LND BOOSTER

PROTOTYPE BUILD

PROJECT: LND150 BOOSTER - TT FORUM		
DESIGN TITLE:		
AUTHOR: Laurent	DRAWING NUMBER Drawing_nr	REV: V3
DATE: 21/11/20	SIZE: A4	SHEET: 1 of 1

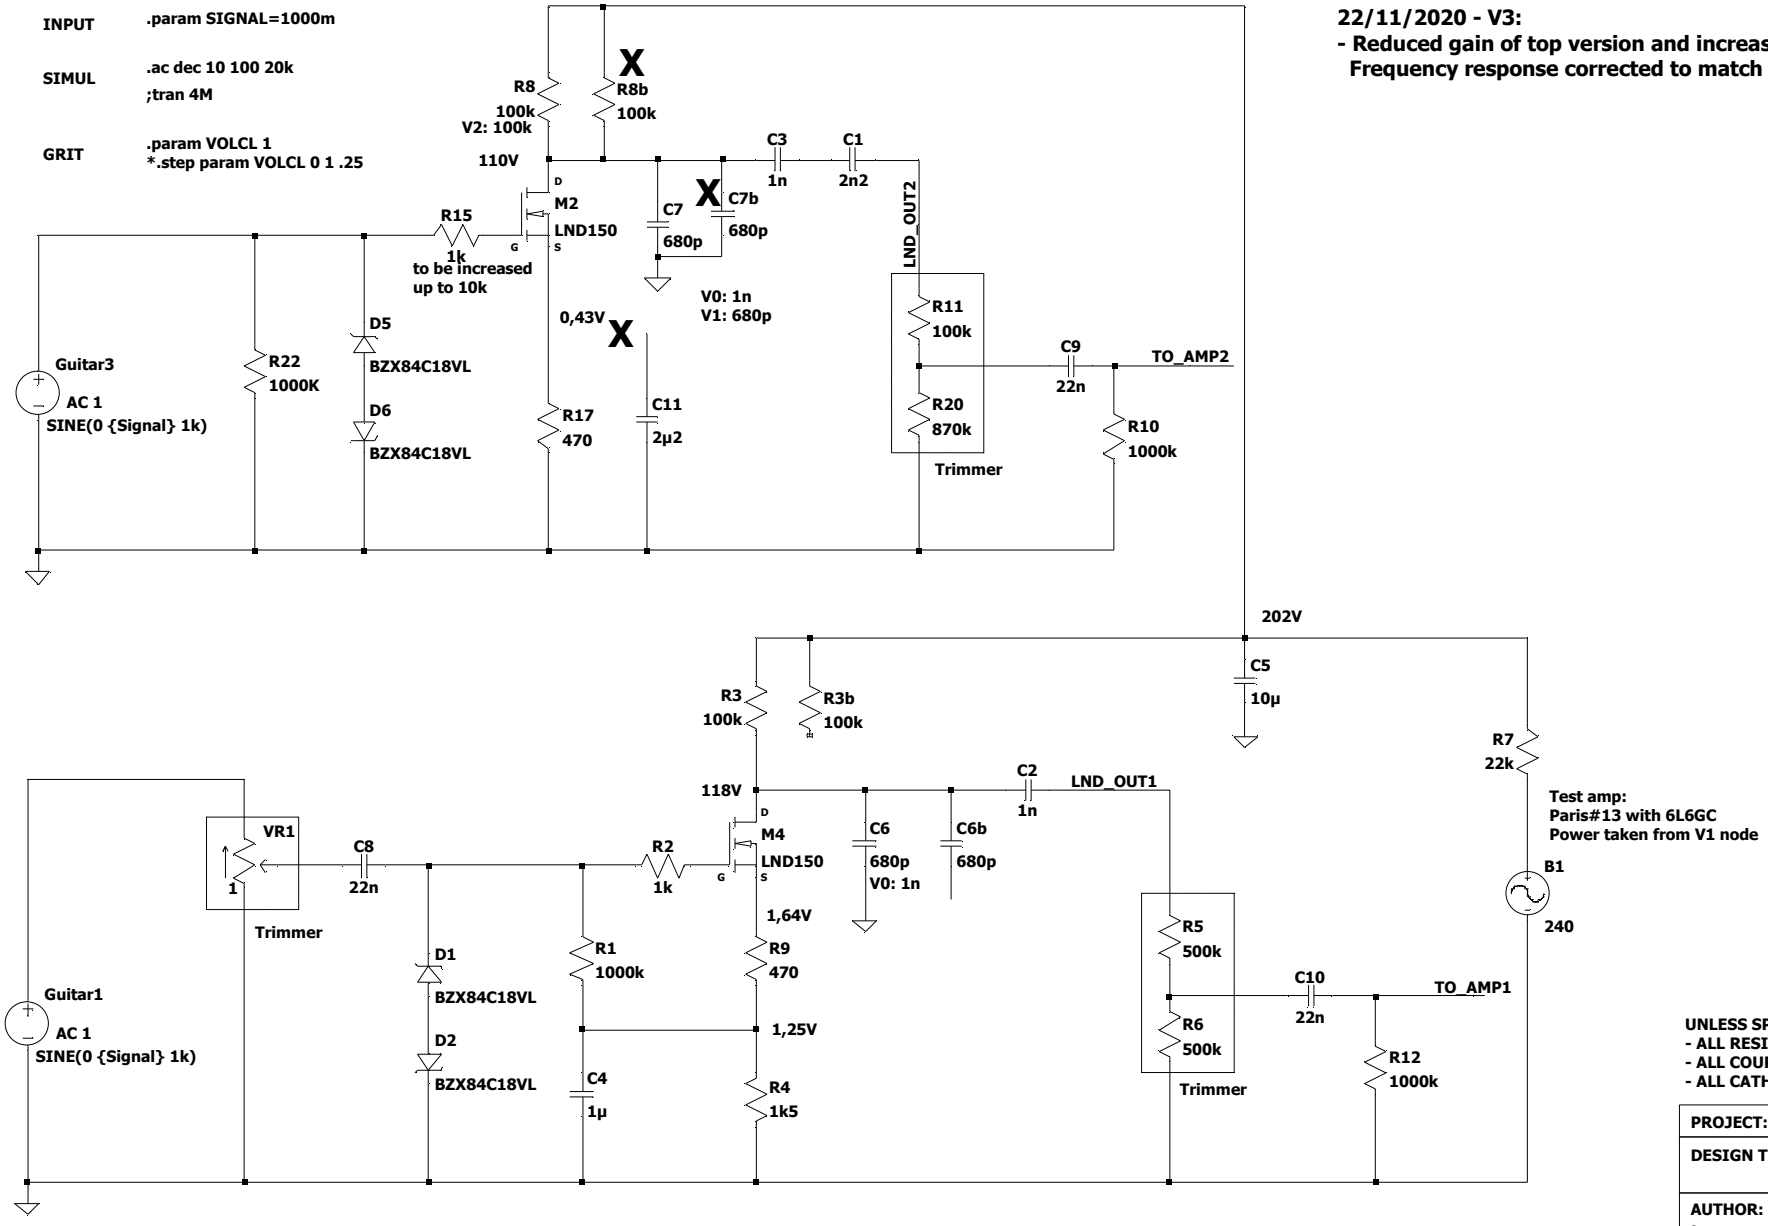
21/11/2020 - V2:
Reduced bleeder cap C6 from 1n to 680pF

22/11/2020 - V3:
- Reduced gain of top version and increased headroom.
Frequency response corrected to match bottom version.
